Well Name: BELL FEDERAL 11	Well Location: T30N / R13W / SEC 11 / SWNW / 36.829525 / -108.181247	County or Parish/State: SAN JUAN / NM
Well Number: 2	Type of Well: OTHER	Allottee or Tribe Name:
Lease Number: NMNM0546	Unit or CA Name:	Unit or CA Number: NMNM104939
US Well Number: 3004532454	Well Status: Gas Well Shut In	Operator: HILCORP ENERGY COMPANY

Sundry ID: 2653168

Type of Action: Plug and Abandonment

CONDITIONS OF APPROVAL

PROPOSED WELLBORE SCHEMATIC

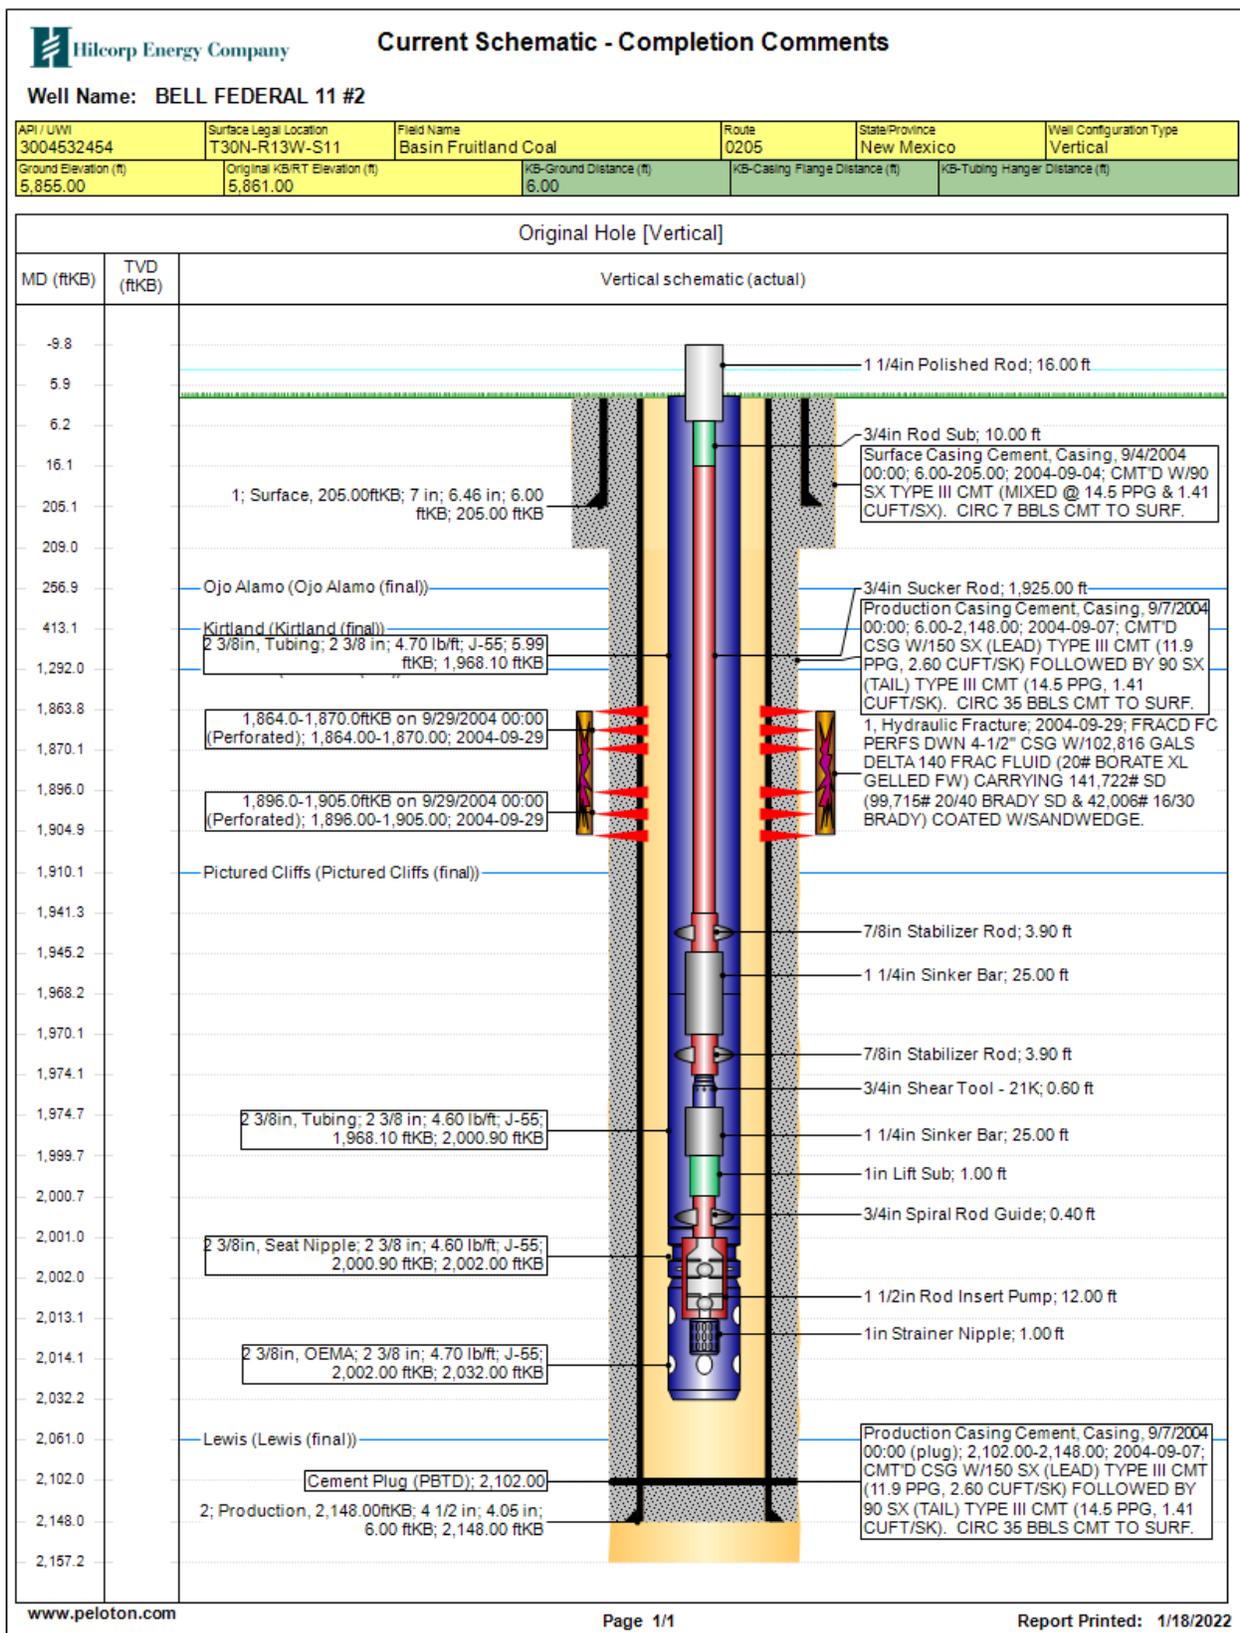
1. Plugging operations authorized are subject to the attached "General Requirements for Permanent Abandonment of Wells on Federal and Indian Lease."
2. The following modifications to your plugging program are to be made:
 - a) Pump a volume of cement below the CICR at 1814' to completely isolate the Fruitland Coal from the Pictured Cliffs. This will satisfy the requirement of adding a plug to cover the Pictured Cliffs formation at 1910' recommended in the BLM Geology Report.
3. Farmington Office is to be notified at least 24 hours before the plugging operations commence at (505) 564-7750.

You are also required to place cement excesses per 4.2 and 4.4 of the attached General Requirements.

- BLM picks for the Lewis and Fruitland formation tops vary from Operator picks.

- Add a plug to cover the Pictured Cliffs formation top at 1910'.
